COMMISSION OF ARCHITECTURAL REVIEW STAFF REPORT August 28, 2018 Meeting

3. COA-039288-2018 (J & L. Sodell)

2717 West Grace Street West Grace Street Old and Historic District

Remove 2nd story rear porch and construct a 2-story rear porch structure.

Google Street View, 2011

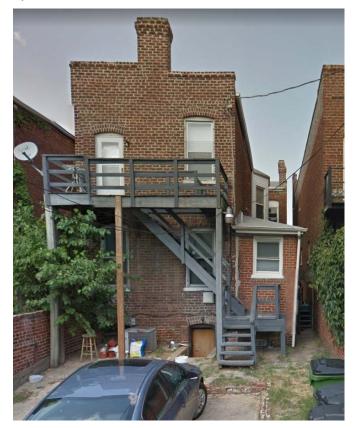
The existing structure is a 2 $\frac{1}{2}$ -story brick Colonial Revival home. At the rear of the home is a 2nd story porch constructed of pressure treated wood. This application is the result of enforcement activity as the porch was constructed without prior approval. An existing wood 2nd story porch was demolished to construct the new porch.

The new structure is 8' by 16' with 3' wide stairs and will not have a roof. The existing porch does not have stairs that access the ground but the plans indicate that stairs will be constructed at the rear of the existing structure. The structure has been constructed of treated wood with a typical deck railing with nailed-up

pickets. Zoning staff has indicated that the structure may not meet setback requirements as built.

Removal of the Existing Porch: The *Guidelines* note that demolition of historic elements is discouraged though it can be permitted when the element is deemed to not be a contributing part of the historic character of the District (pg. 82). A rear porch does not appear on the Sanborn maps or assessor's card for the property dating from the 1950s to the 1980s. Staff does not find that the prior porch was a character defining, contributing feature to the historic structure and recommends approval of the demolition of this element.

New 2-Story Porch: The *Guidelines* state that new construction should use a building form compatible with that found elsewhere in the historic district (pg. 46, Form #1). The 2-story rear porch structure is a form found in the district. The proposed structure is consistent with the Commission's guidelines for decks (pg. 51) as it is in the rear and small in scale. <u>Staff recommends that Richmond rail be installed to replace the nailed-up pickets and the structure be painted or opaquely stained a neutral color that complements one or more of the colors found on the main structure.</u>

Staff recommends approval of the project with conditions.
